JRPP NO.:	2011SYW018
Section 96 Application No. :	DA0710/09A
Proposed Modification:	Modification to ring towers/structures and inclusion of tower cranes - Lot 181 DP 39768, 2 College Road, Richmond
Applicant:	Charles Vella, c/- University of Western Sydney
Submission:	Nil
Report by:	Colleen Haron, Senior Town Planner, Hawkesbury City Council

Assessment Report and Recommendation

**Proposed Modified Development
Elevation Plan 1
Lot 181 DP 39768 Londonderry Road and The Driftway, Richmond**

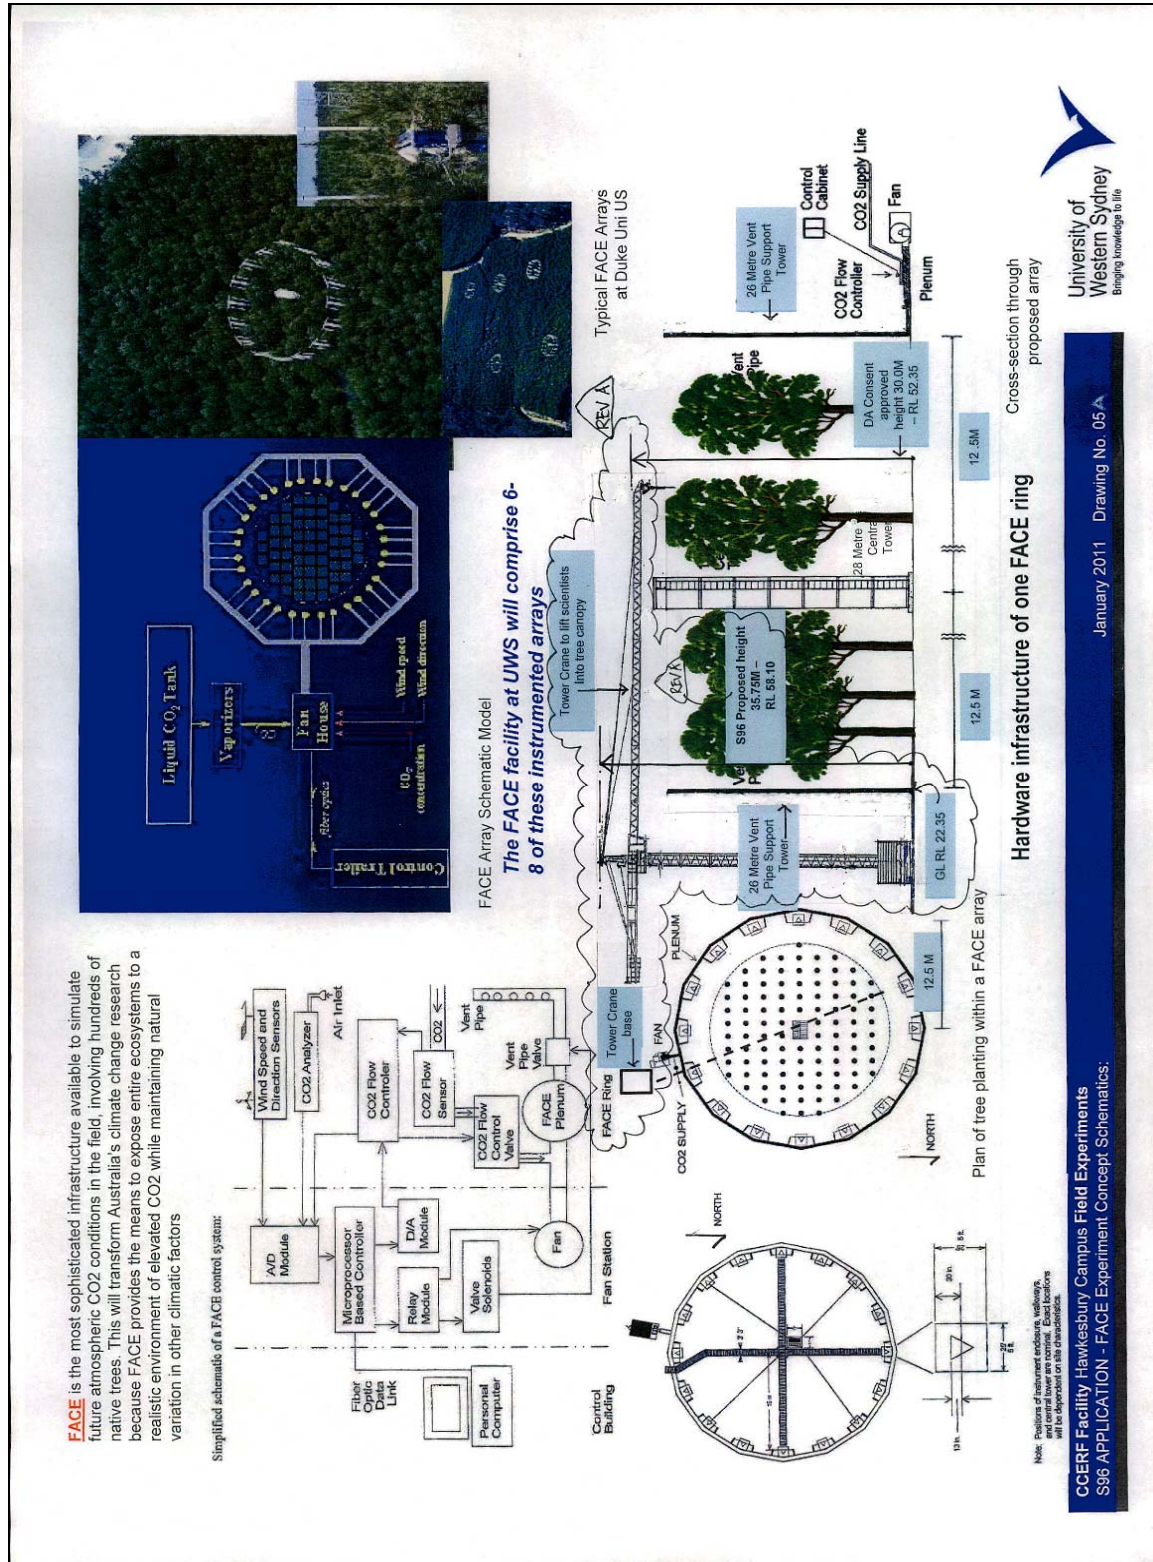
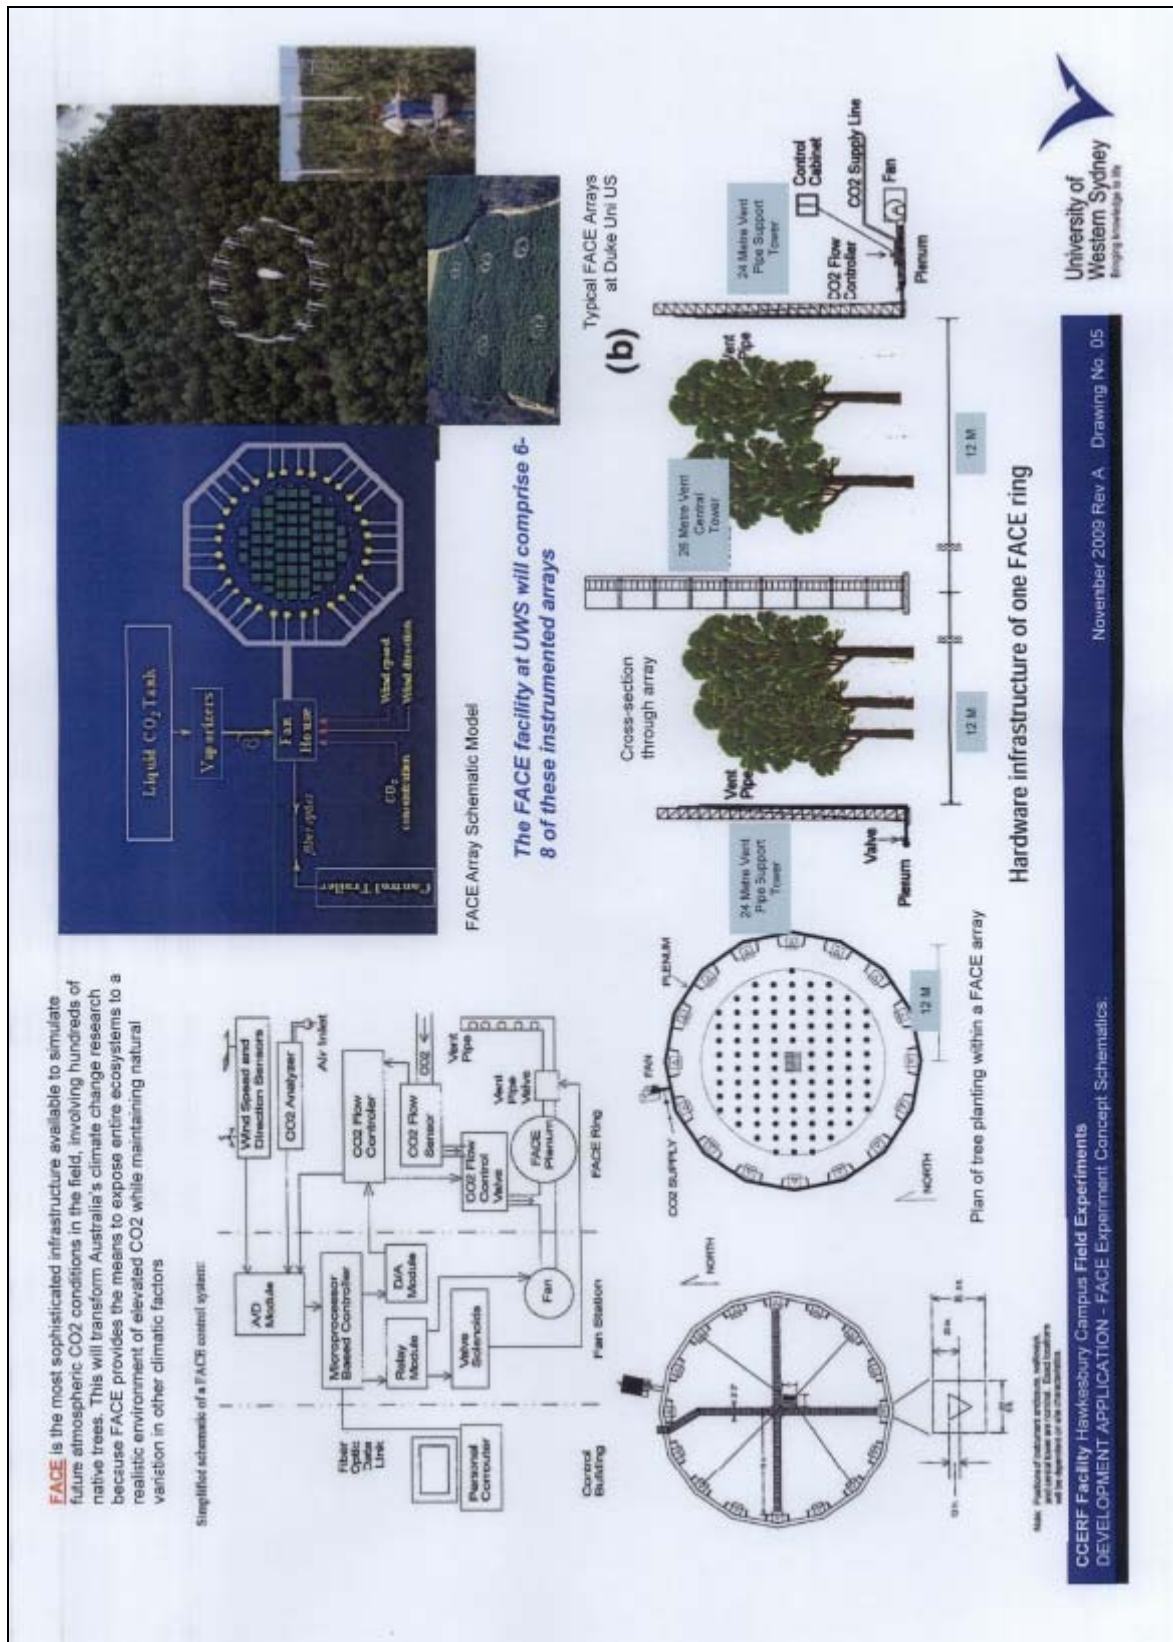
The modification application proposes to alter the towers within the rings by reducing their diameter and increasing the outer towers to a height to 26 metres and the central tower to a height of 28 metres. The amended design of these towers eliminates the need for concrete bases for each tower, as they will be secured by a 'screw-pile' method. A tower crane will be positioned adjacent to each ring array to provide access for researchers to the tree canopy and to assist in the construction of the rings. The tower cranes will have a height of 35.75m above natural ground level.

It is considered that the proposed modified tower rings and crane will not be dominant in the landscape as they are well set back from nearby roads and are situated in excess of 80m from any adjoining development. Further, given the setback of the tower rings and crane from The Driftway and Londonderry Road, and the presence of bushland surrounding their location, it is considered that the modified structures will have no adverse visual impacts. The modified design of the structures is narrower and less bulky in appearance when compared to those previously approved.

3. The maximum height of the ring towers and tower cranes shall not exceed 35.75m to ensure that the Department of Defence requirements are not breached and visual impact is minimised.
